APPLICATION FOR AMENDMENT NO. 5

MEMPHIS STATE UNIVERSITY FACILITY OPERATING LICENSE
NO. R-127, DOCKET 50-538

IV. PROPOSED AMENDMENT NO. 5 TO OPERATING LICENSE R-127

FIGURE 1. REACTOR FACILITY SAFSTOR ORGANIZATION"

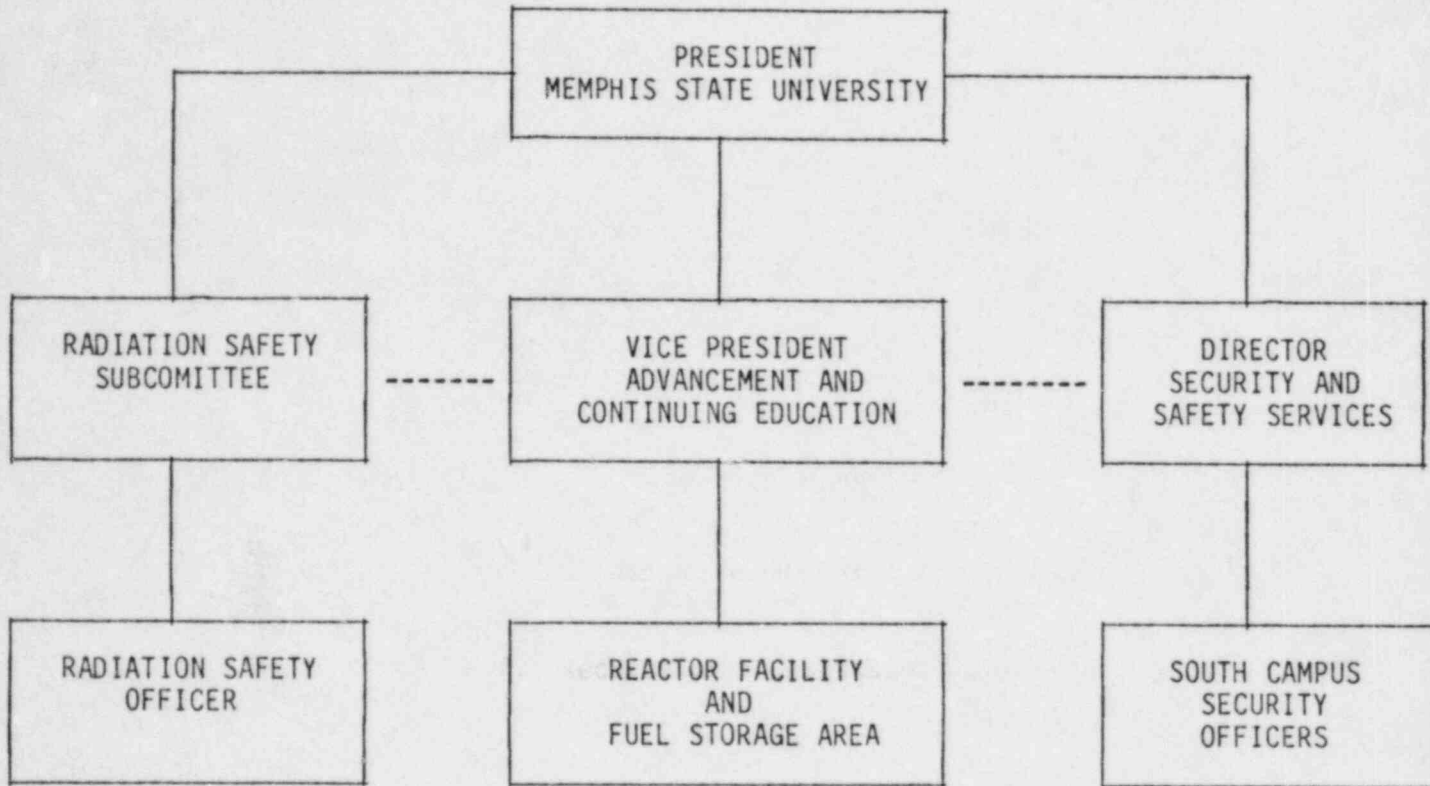
6.1 Organization, Responsibilities and Authority. Responsibility for protective storage of the reactor facility shall be with the organization shown in Figure 1 of this section. Individuals at the various management levels shall be responsible for safeguarding the public and facility personnel from undue radiation exposures and for adherence to all requirements of the facility license. Assignment of specific responsibilities shall be as described in the following paragraphs.
